UNITED STATES
NUCLEAR REGULATORY COMMISSION
ADVISORY COMMITTEE ON REACTOR SAFEGUARDS
WASHINGTON, D. C. 20555
September 23, 1985

SUBJECT: PALO VERDE UNIT 1 LOSS OF LOAD EVENT

PRESSURIZER AUXILIARY SPRAY
DESIGN REVIEW

OCTOBER 8, 1985

FIGURE 2.1-4

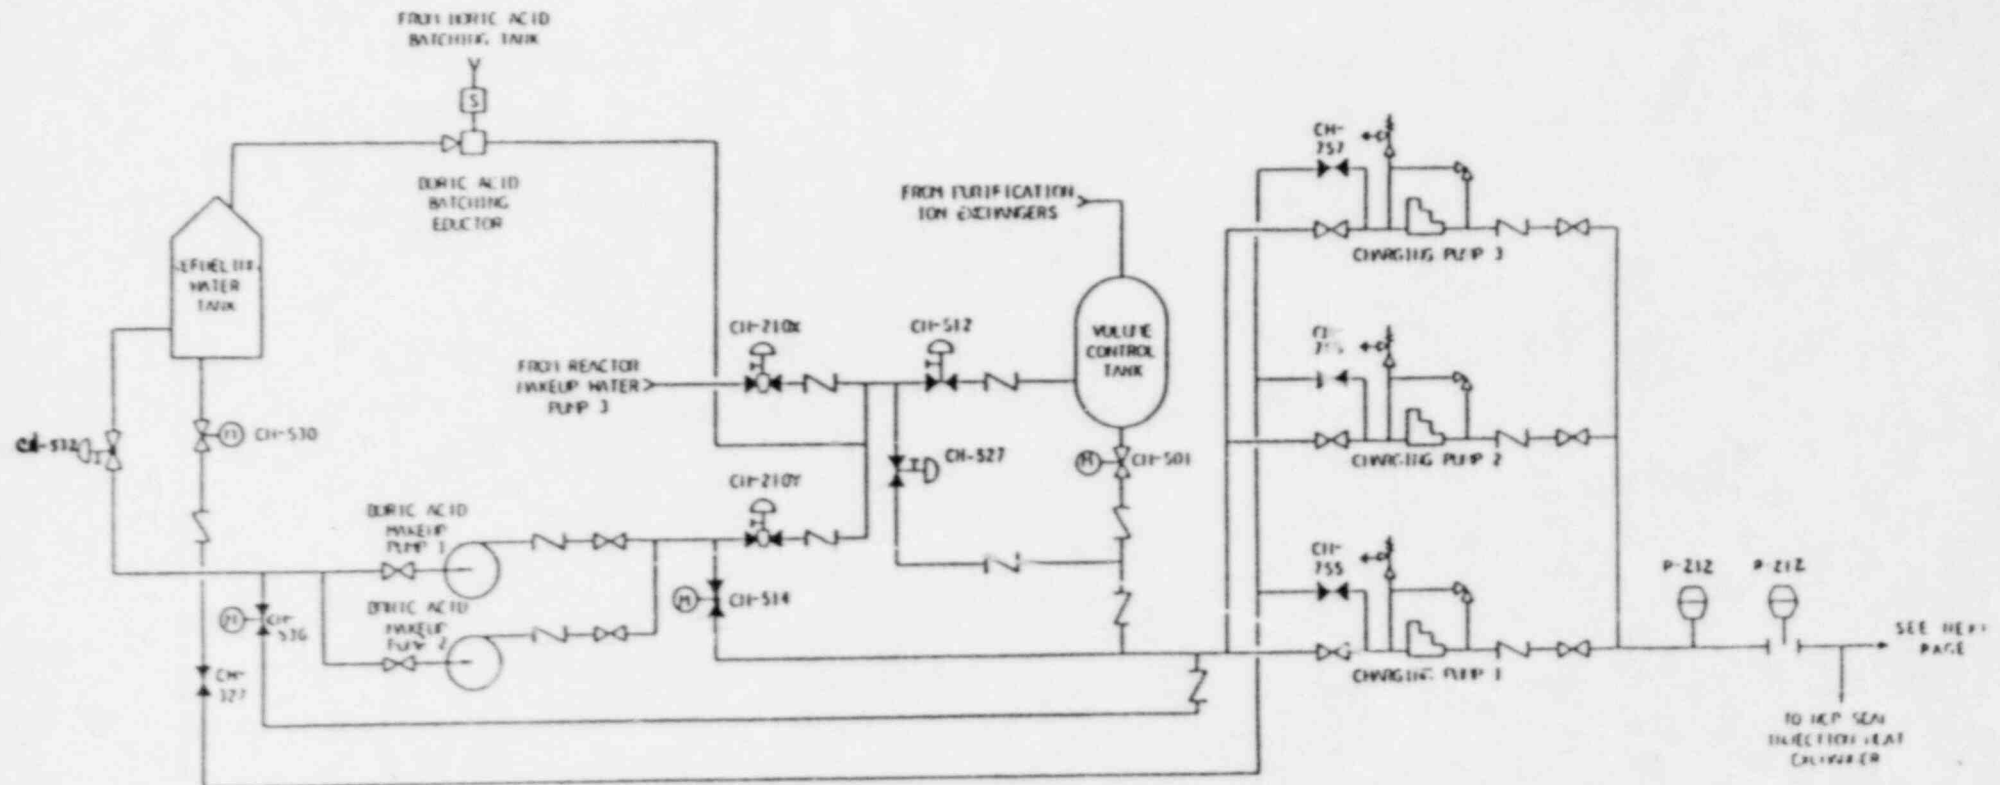
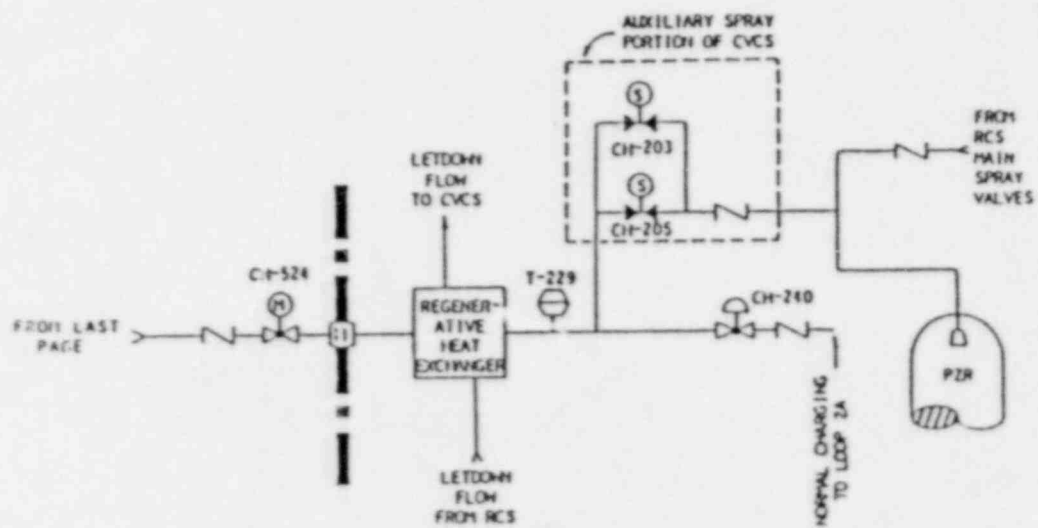
- o SUPPLEMENT NO.1 OF THE CESSAR SAFETY EVALUATION REPORT (ISSUED MARCH 1983) CONCLUDED THAT "THE GUIDELINES OF BTP RSB 5-1 HAVE, THEREFORE, BEEN SATISFIED AND THIS ISSUE IS RESOLVED."
- o IN CEN-239, COMBUSTION ENGINEERING AND ARIZONA PUBLIC SERVICE RESPONDED TO NRC REQUEST FOR ADDITIONAL INFORMATION ON THE DESIGN AND OPERATION OF THE AUXILIARY PRESSURIZER SPRAY SYSTEM
- o CEN-239 STATED THAT "AUXILIARY SPRAY PROVIDES THE SAFETY-RELATED METHOD FOR RELATIVELY RAPID AND CONTROLLED DEPRESSURIZATION OF THE RCS TO COLD SHUTDOWN CONDITIONS. AS SUCH THE SYSTEM HAS A DEGREE OF PERFORMANCE CONSISTENT WITH THE NRC BRANCH TECHNICAL POSITION RSB 5-1."
- o IN NUREG-1044, NRC STAFF EXPRESSED CONCERN ABOUT SINGLE FAILURE VULNERABILITY OF VALVE CH-240. CONCERN WAS RESOLVED BY ADDING VALVE CH-239, IN SERIES WITH CH-240

VALVE POWER SUPPLY CHANGE

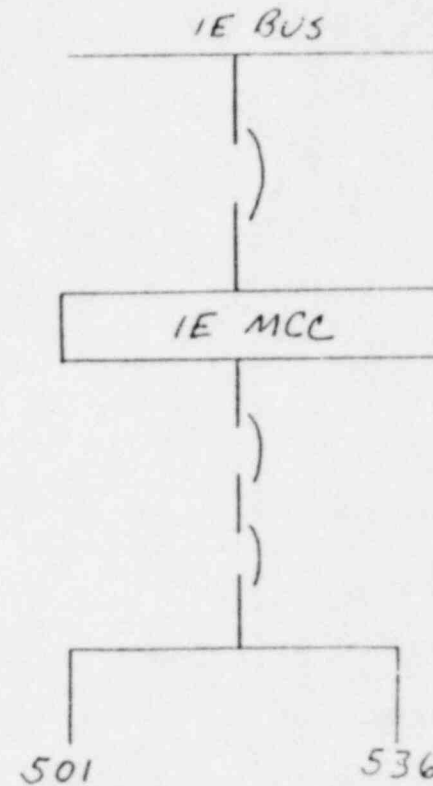
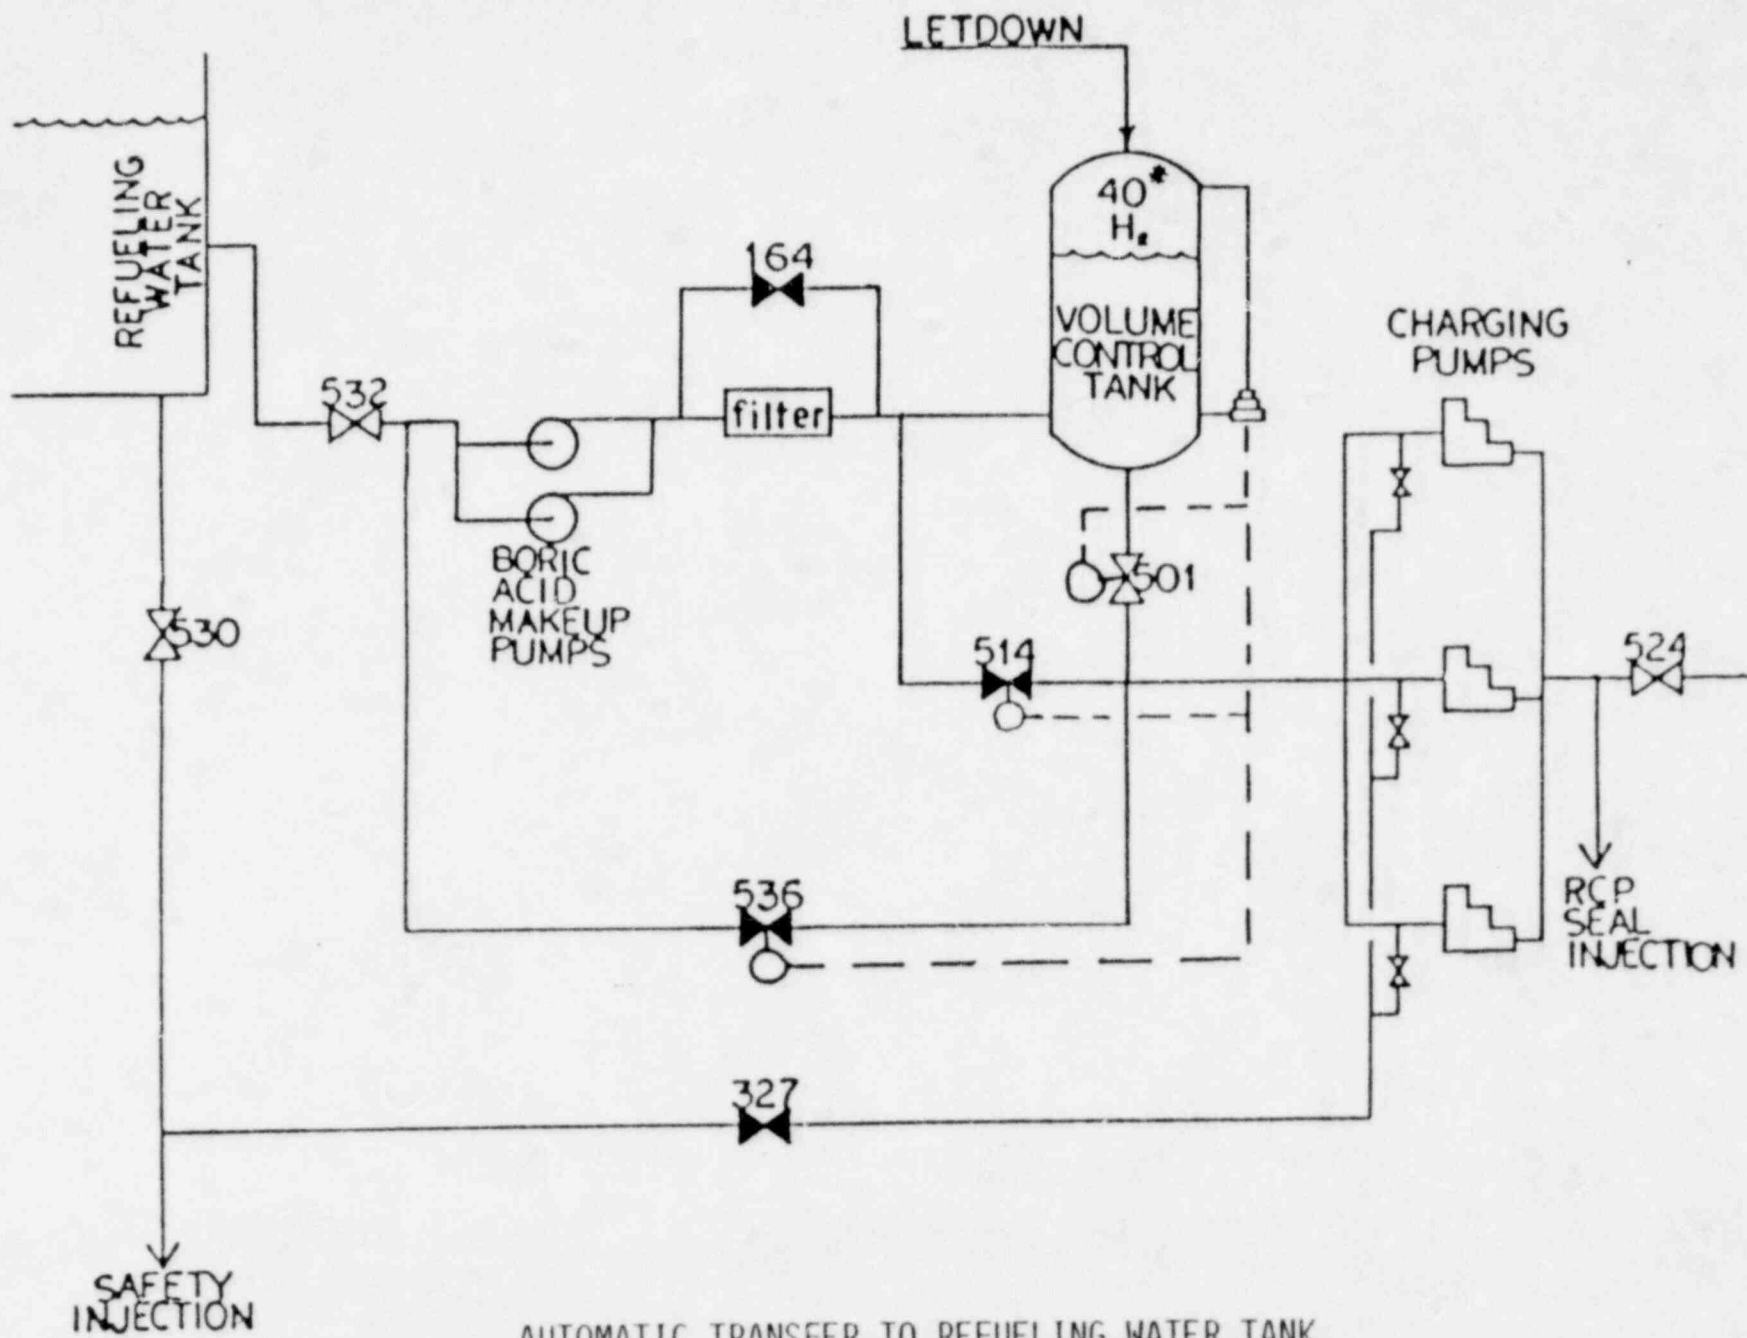
- o REPORT OF ACTIONS UNDERTAKEN TO ADDRESS SEPTEMBER 12, 1985
EVENT (PER SEPTEMBER 20, 1985 MEETING)
- o THREE MODIFICATIONS PLANNED
 - ENSURE CONTINUED CONTROL OF V501 AND V536
FOLLOWING LOP AND SIAS
 - ADD SECOND, DIVERSE REFERENCE LEG FOR VCT
LEVEL MONITORING WITH ALARM
 - AUTOMATIC REALIGNMENT OF V501 AND V536

CHANGE ENSURES OPERABILITY FROM CONTROL ROOM AFTER SIAS AND LOP SUCH THAT SUCTION COULD BE ALIGNED TO RWT FROM VCI.
